MEMORANDUM

Subject: N2 WillowWood Plaza Residential Concept (10300 & 10306 Eaton Place)

Meeting Date: April 25, 2022

Pre-Application Briefing – Planning Commission

Site Plan

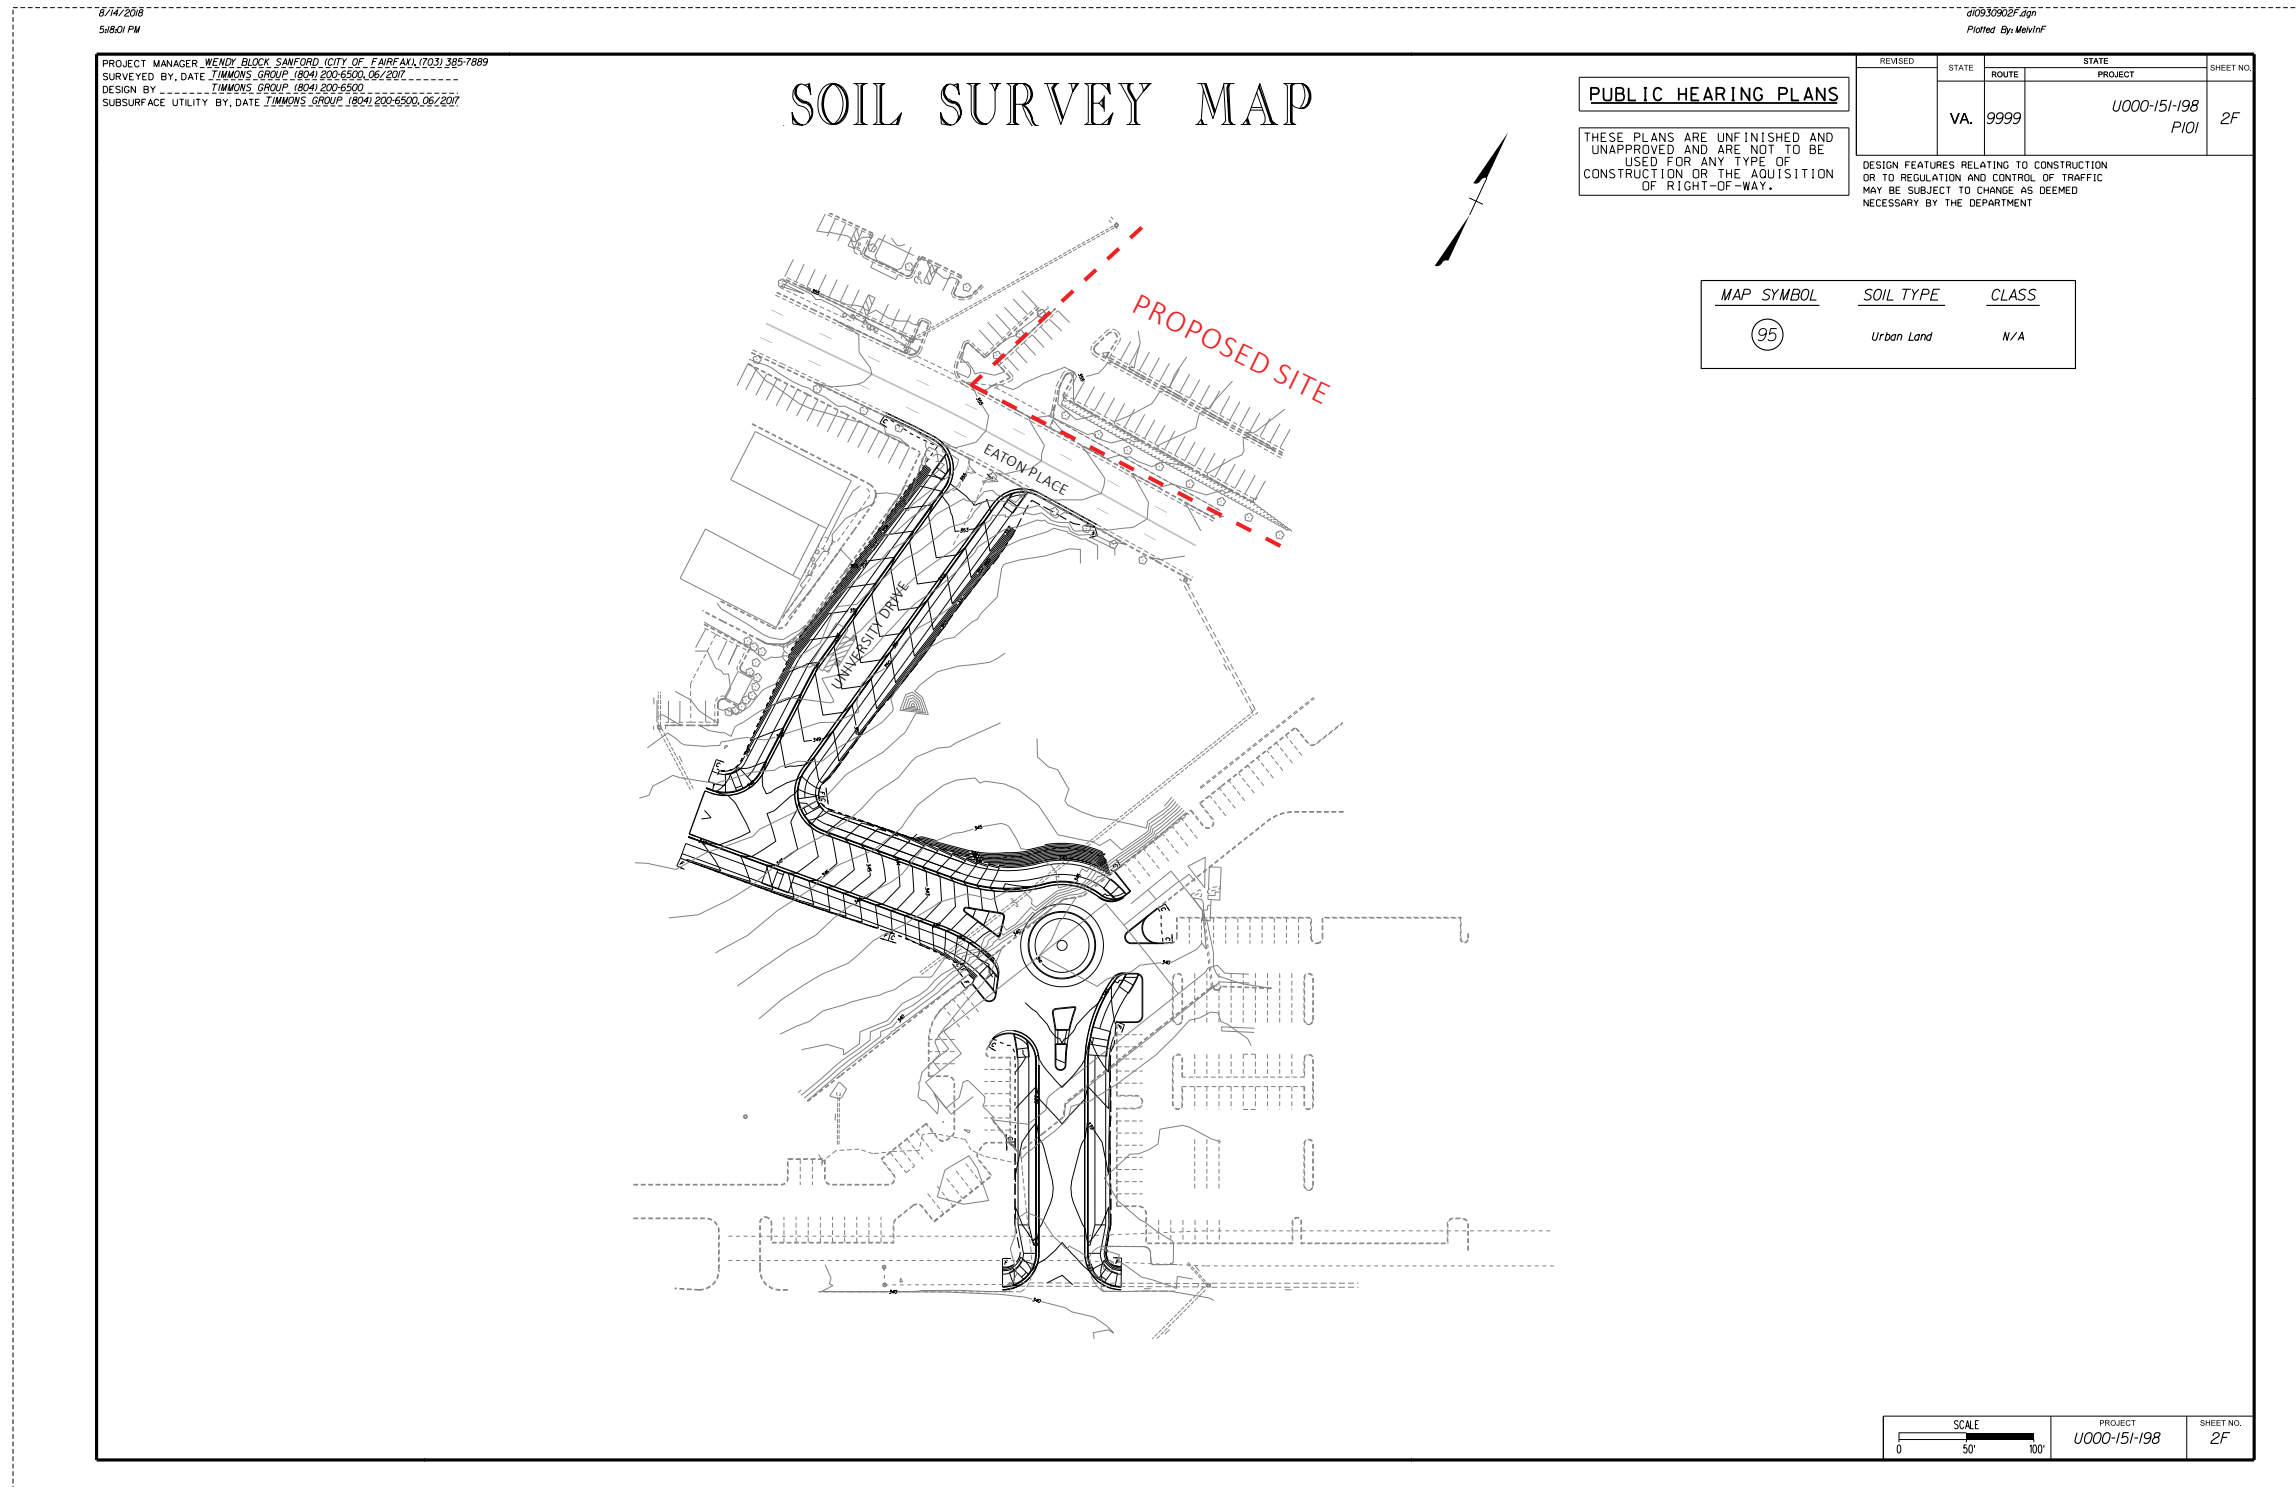
- Concept would need to provide connections through the site consistent with the Small Area Plan.
- Concept would need to make sure the new streets are aligned with existing intersections. The entrance on the western side should remain aligned with the University Drive extension.

- All surface lanes designated as a fire lane would need to meet the minimum width with approved signs and with curb/surface striping.
- The fire lanes running parallel with the western and eastern sides of the apartment building and new parking deck must be a minimum of 26 feet wide due to close proximity to the multi-story buildings and the need to properly position aerial apparatus. The eastern lane will serve both new and existing buildings.

- Any dead-end lanes in excess of 150 feet must be provided with an approved turnaround for fire apparatus.
- Provide fire apparatus turning movement in all directions using specs for Tower Ladder 403 (City of Fairfax).

- Fire hydrants will need to be provided within 100 feet of all FDCs. The apartment building and both parking decks must have two (2) FDCs at approved remote locations.

- The stormwater management facilities run through the site and under the proposed two-over-two section would need to be accounted for in the site design.
